# Access Compliance Report

## Public Rights-of-Way

### (Curb Ramps)

Intersection ID: 9440	Main Street: BRADFORD_DR	Cross Street: EDGEWOOD_RD	Location: E
ADA ID: 899C6ADFDB0F	Ramp Type: Perp	Initial Pass/Fail: Fail	Overall Compliance: No
		Severity Score: 12.5

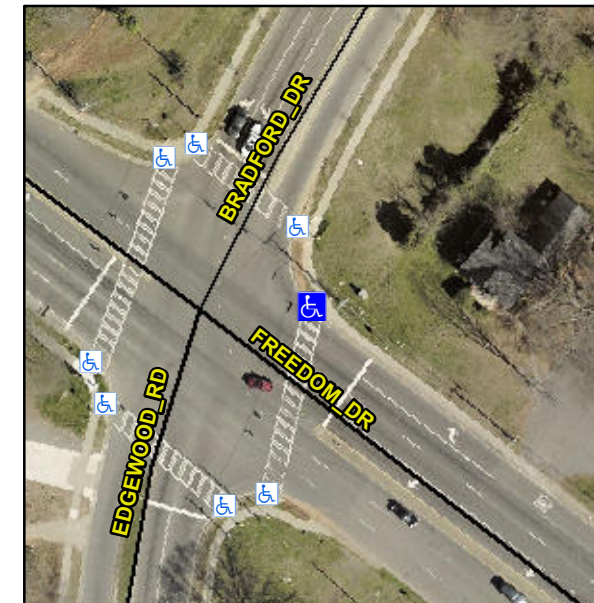
**Not Found, R304.2.2**

Compliance	Description	Data	Compliance	Description	Data
N/A	Ramp Length (in)	60.0	No	Ramp Slope (%)	9.2
Yes	Ramp Width (in)	48.0	Yes	Ramp XSlope (%)	0.3
N/A	Flare Type LT	N/A	N/A	Flare Type RT	N/A
N/A	Flare Slope LT (%)	N/A	N/A	Flare Slope RT (%)	N/A
N/A	Flare Traversable LT?	N/A	N/A	Flare Traversable RT?	N/A
N/A	Landing Length (in)	N/A	N/A	DWS Provided?	N/A
N/A	Landing Width (in)	N/A	N/A	DWS Contrast?	N/A
N/A	Landing Slope (%)	N/A	N/A	DWS Length (in)	N/A
N/A	Landing X Slope (%)	N/A	N/A	DWS Full Width?	N/A
N/A	Landing Curb? (Y/N)	N/A	N/A	DWS Offset (in)	N/A
N/A	Shared Landing?	N/A			
N/A	Gutter Ponding?	N/A	N/A	Gutter Slope (%)	N/A
N/A	Gutter Lip Ht (in)	N/A	N/A	Gutter X Slope (%)	N/A
N/A	Painted X Walk1?	Yes	N/A	Painted X Walk2?	N/A
	X Walk 1 Direction	To SW		X Walk 2 Direction	N/A
N/A	X Walk 1 Width (in)	124.0	N/A	X Walk 2 Width (in)	N/A
	X Walk 1 Slope (%)	2.0		X Walk 2 Slope (%)	N/A
	X Walk 1 X Slope (%)	0.3		X Walk 2 X Slope (%)	N/A

**Remove & Replace Entire Ramp.**
